TECHNICAL MEMORANDUM 002
BLOCK 675 EAST
CEQR No. 17DCP159M
ULURP Nos. C180127 ZMM, N180128 ZRM, N180128(A) ZRM, C180129
ZSM, 180129(A) ZSM, C180150 ZMM, C180152 ZSM, N180151 ZRM,
N180151(A) ZRM, 180152(A) ZSM

HEIGHT REDUCTION ON PROJECT SITE A

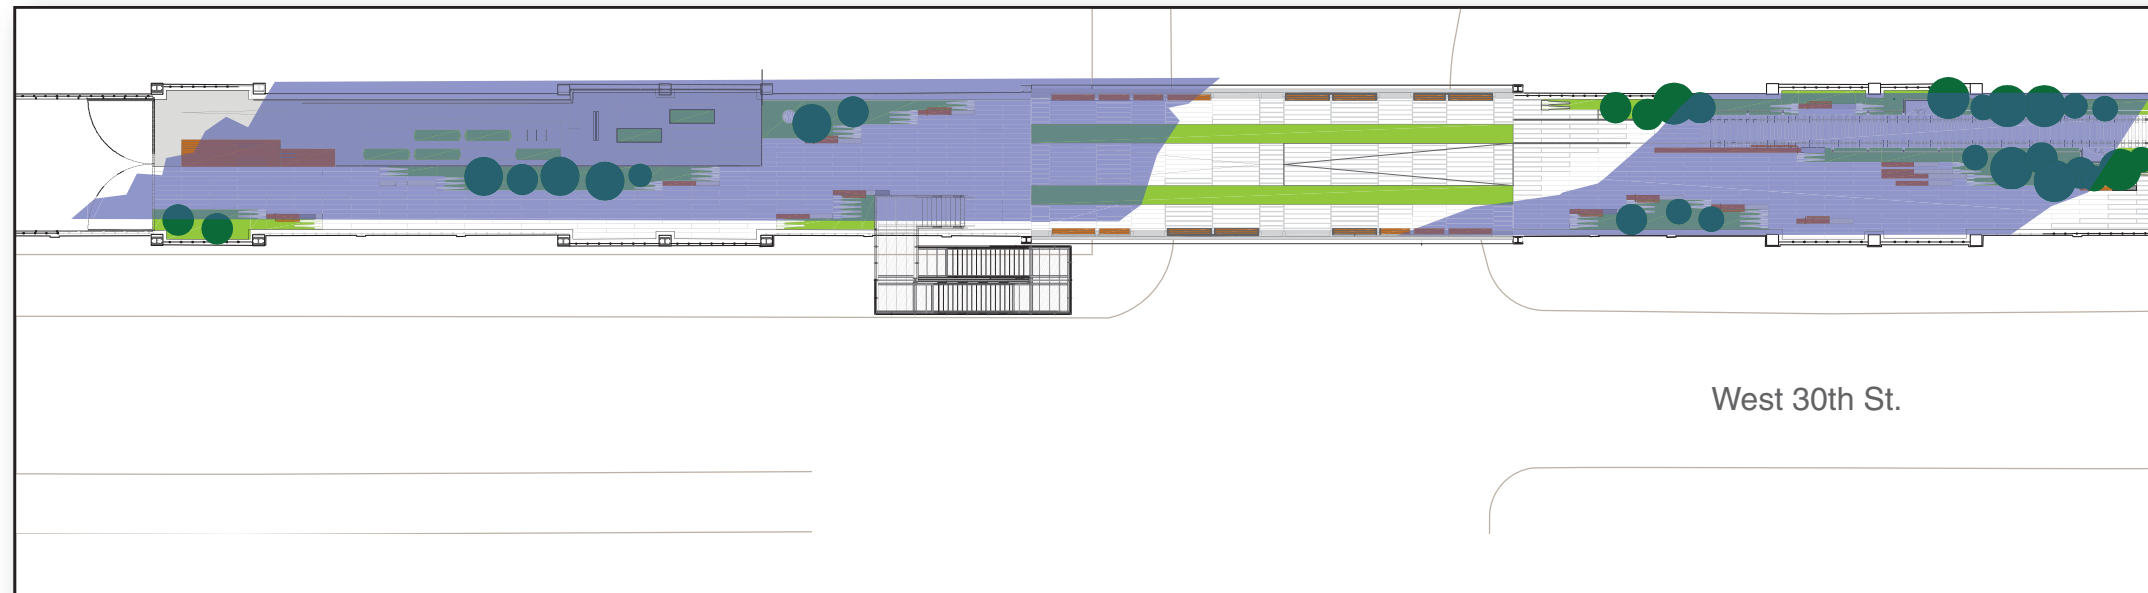
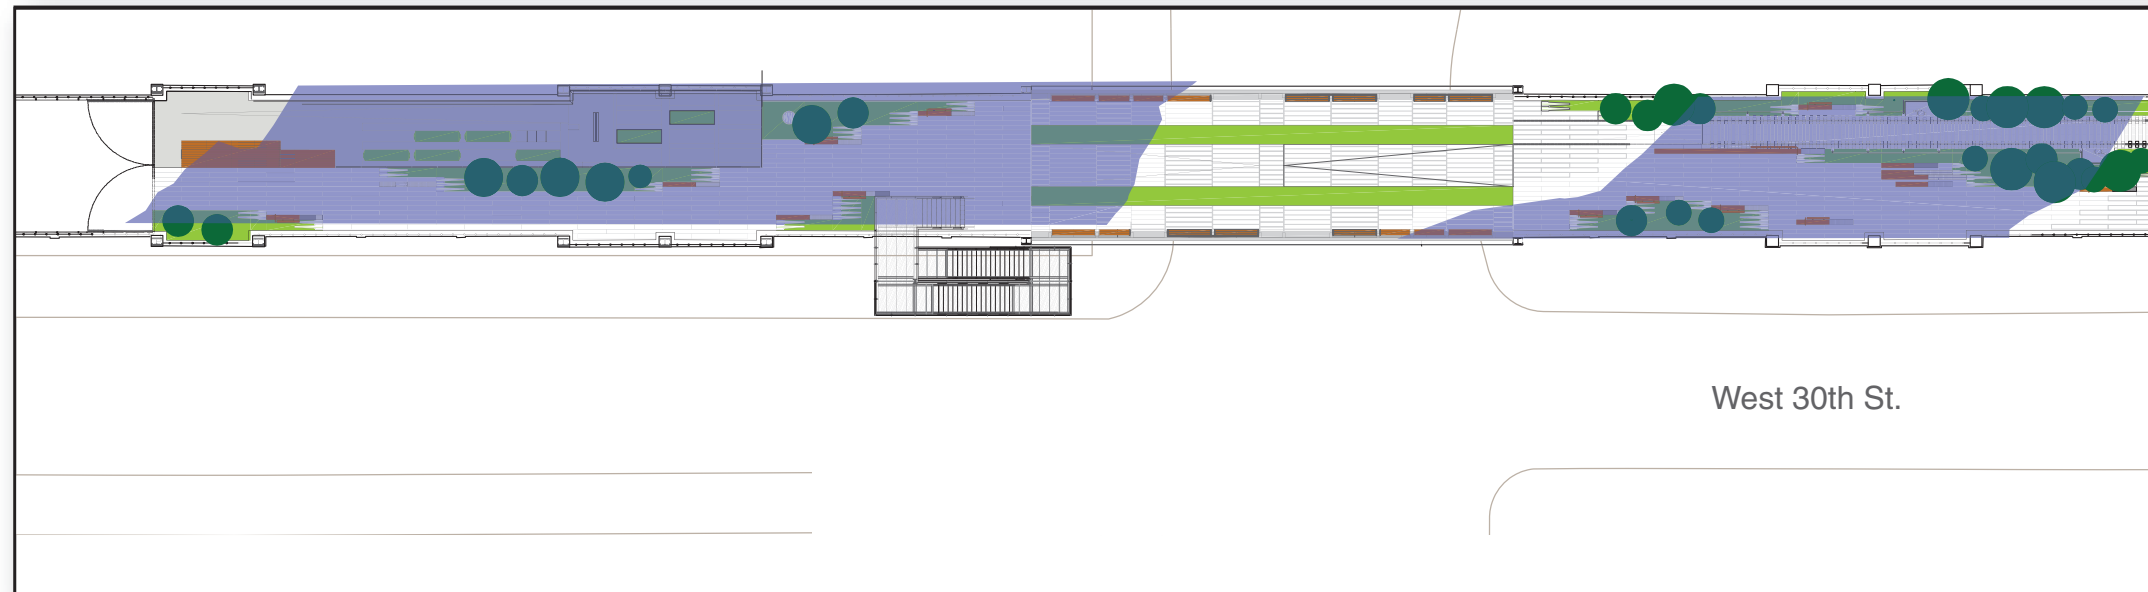
Figure 2 shows a comparison of shadow conditions at the affected area of the High Line on the March 21/September 21 analysis day, reflecting both the FEIS design and the currently contemplated reduced height building on project site A.

While there are very small reductions in areas that would receive less than four to six hours of direct sunlight, these changes would not be such that the impact identified in the FEIS would be eliminated or meaningfully reduced. The proposed actions with a reduced height building on project site A would still result in significant adverse shadow impacts to vegetation on portions of the High Line on the March 21/ September 21 analysis day. Therefore, the conclusions of the FEIS remain valid and the mitigation measures identified in the FEIS remain appropriate.
